901 NORTH CAPITOL STREET NE ZONING COMMISSION SUBMISSION

PREVIOUSLY APPROVED - ZC CASE NO. 21-09

901 NORTH CAPITOL STREET NE ZONING COMMISSION SUBMISSION : JUNE 16, 2023

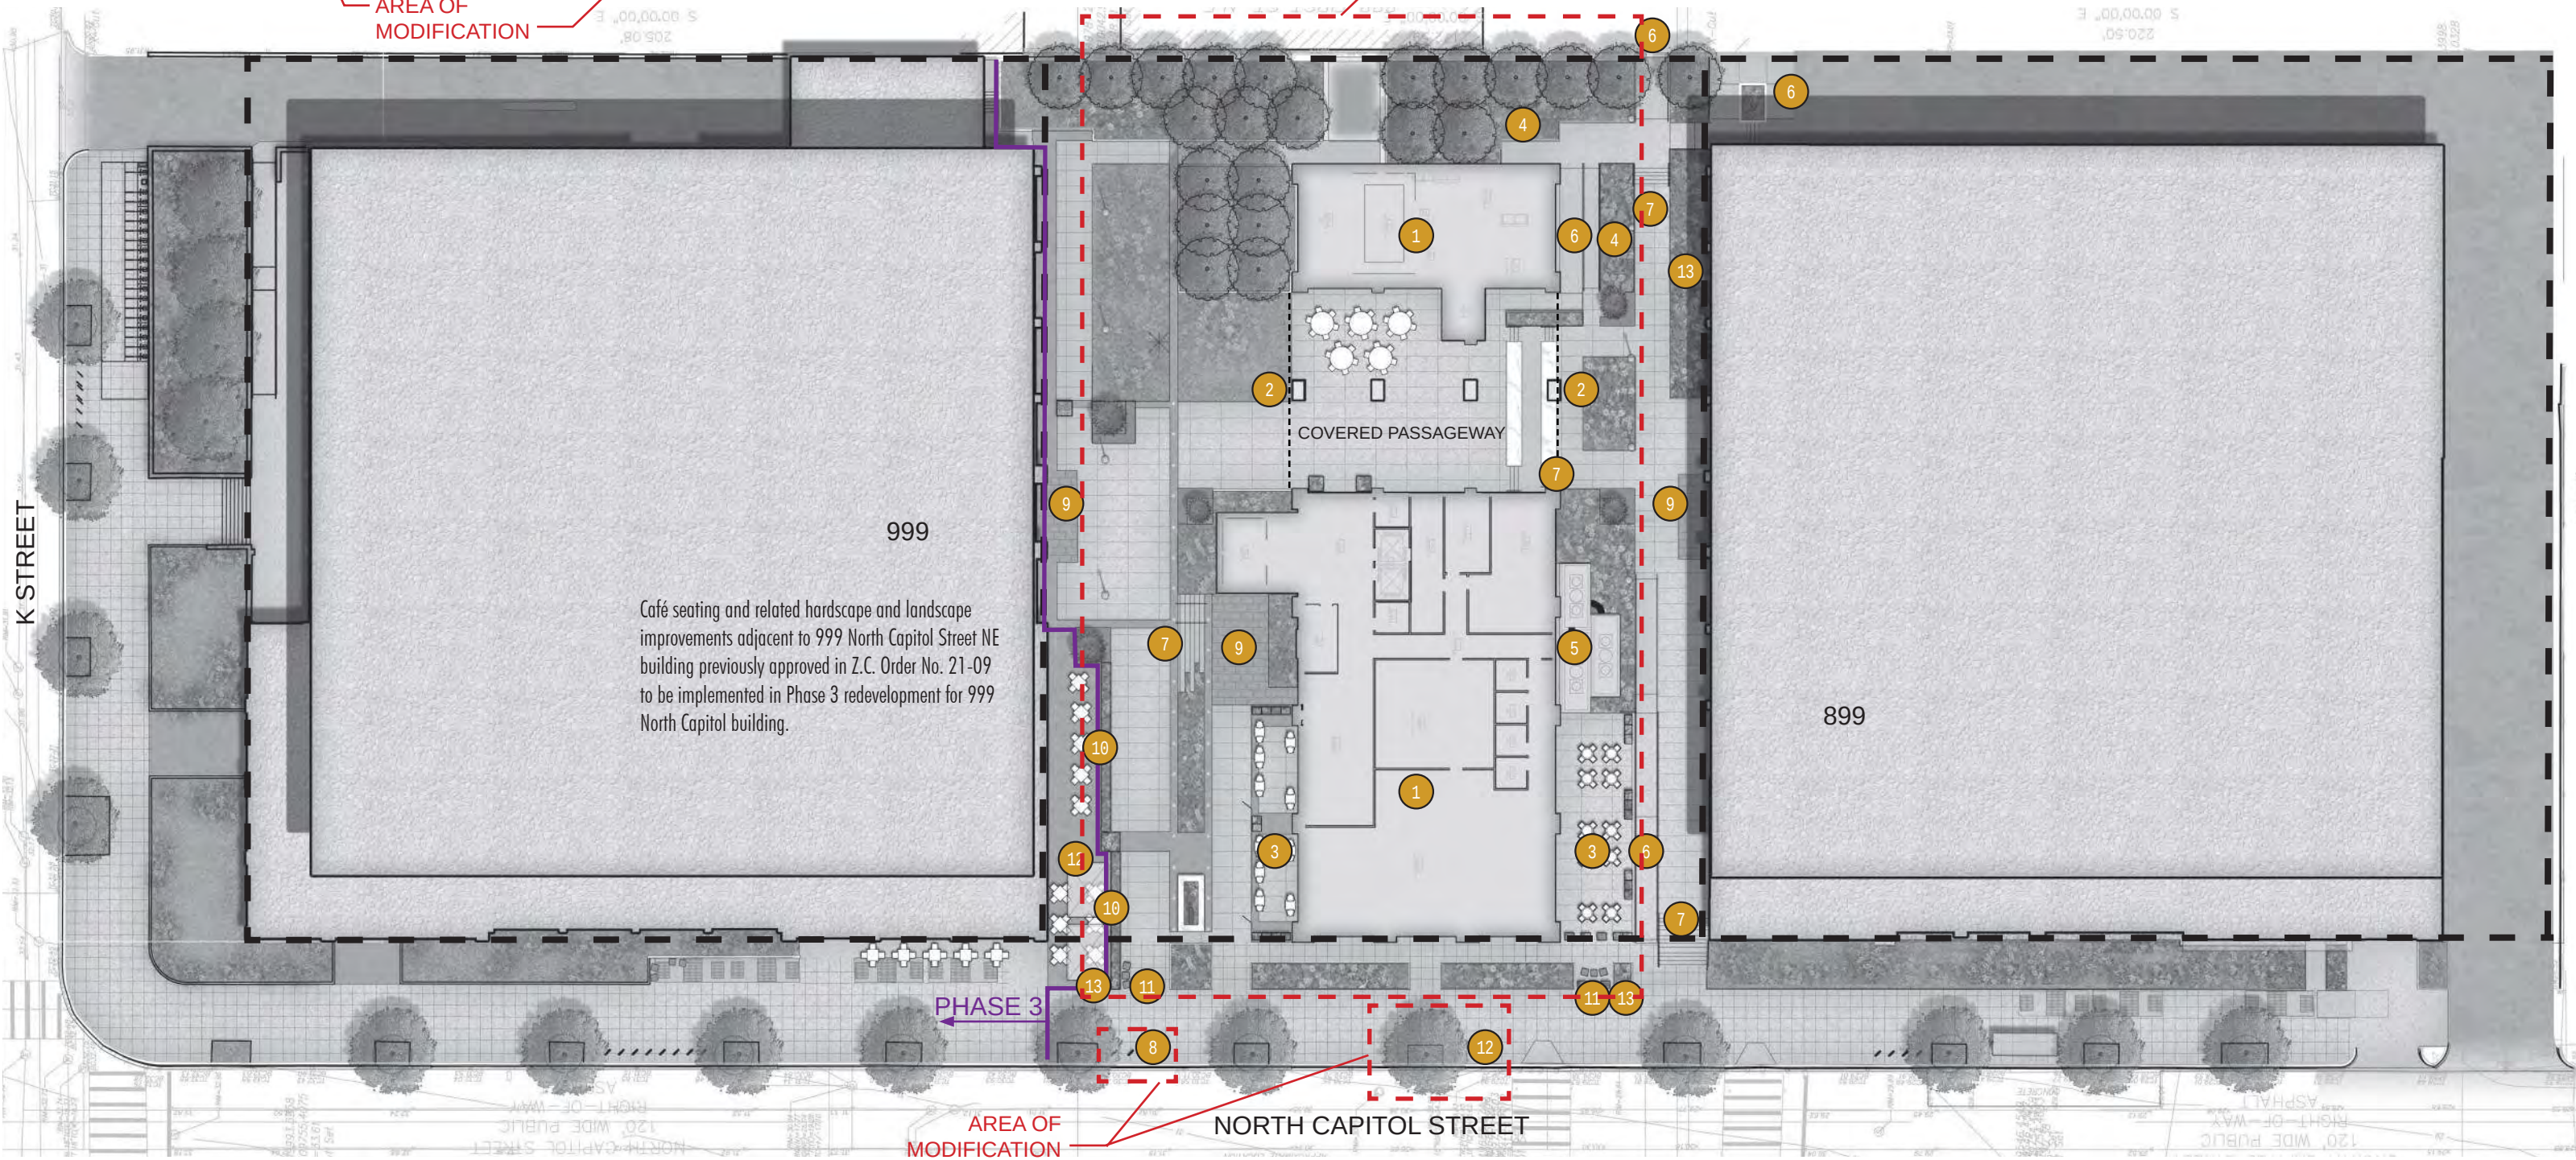
Modifications:

- Unit pavers updated to smaller areas of concrete paving;
- Furniture in covered passageway revised;
- Decorative pots and planters revised in quantity and size;
- Public seatings relocated;
- Bike racks added.

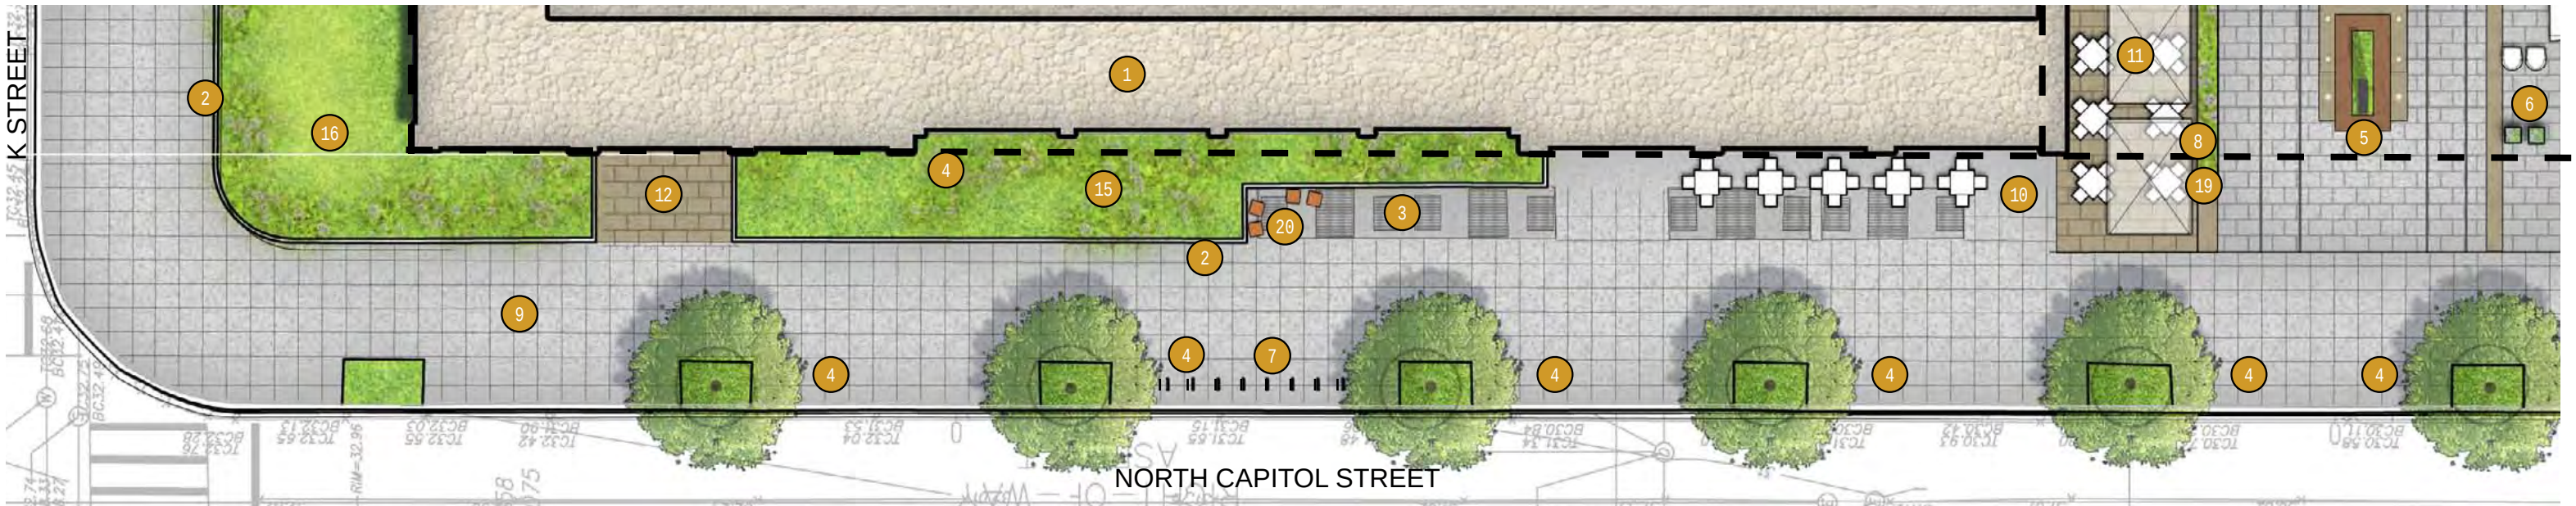
Modifications:
-Bike racks added and revised to another product.

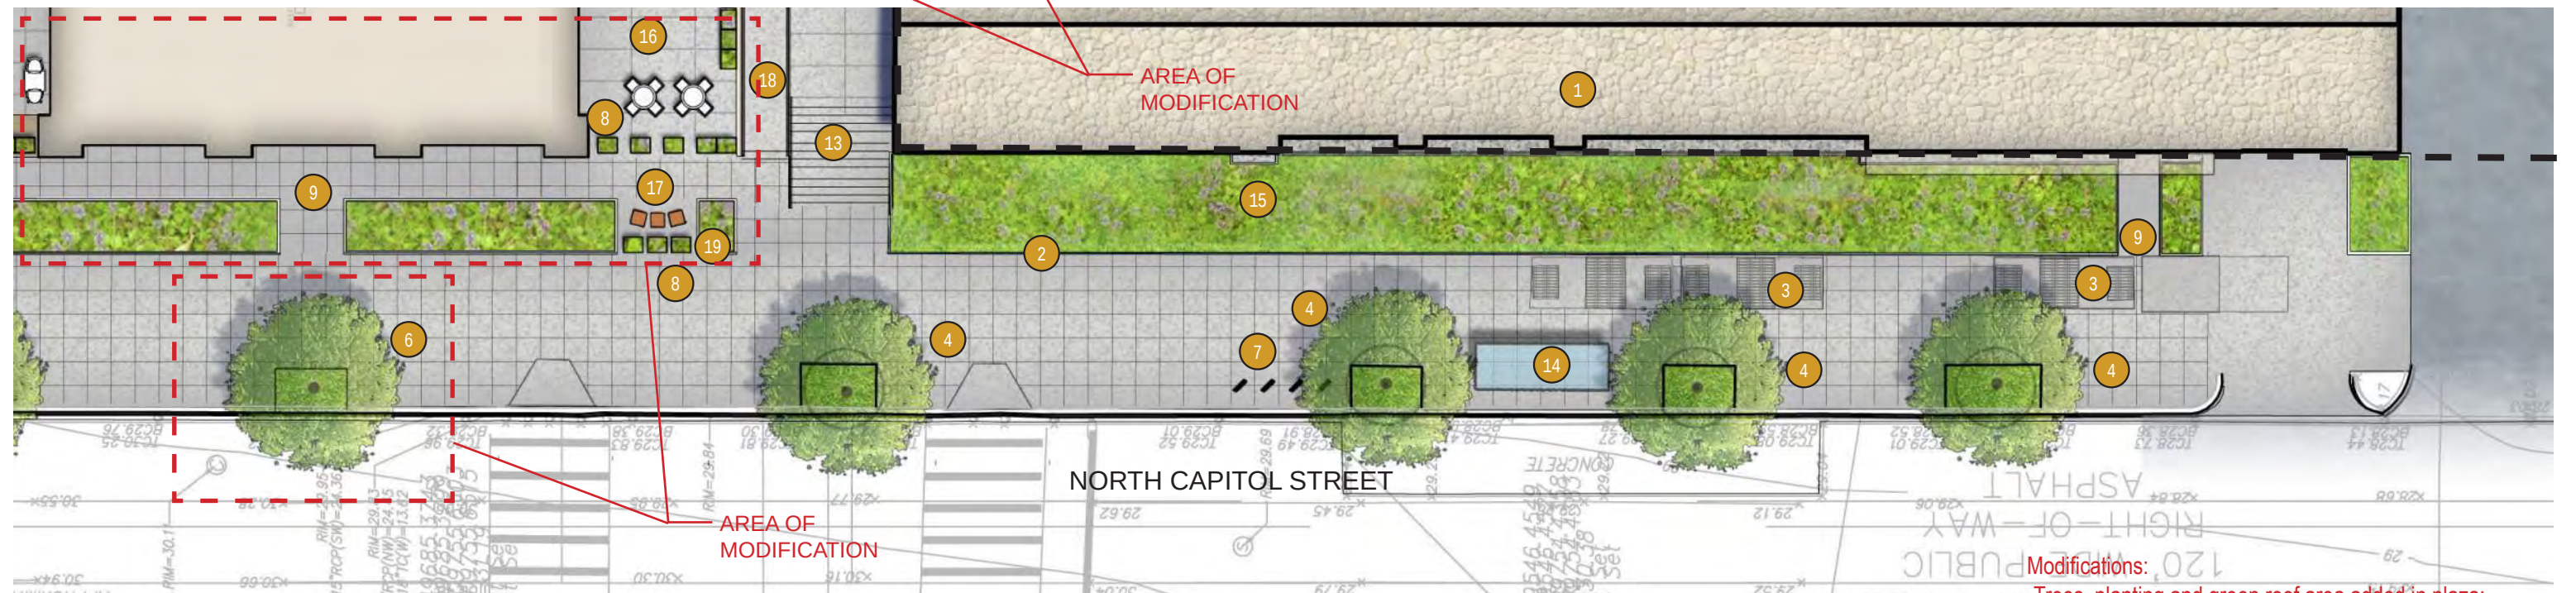
Modifications:

- Trees, planting and green roof area added in plaza;
- Unit pavers updated to smaller areas of concrete paving;
- Decorative pots and planters revised in quantity and size;
- Public seatings relocated;
- Street tree added.
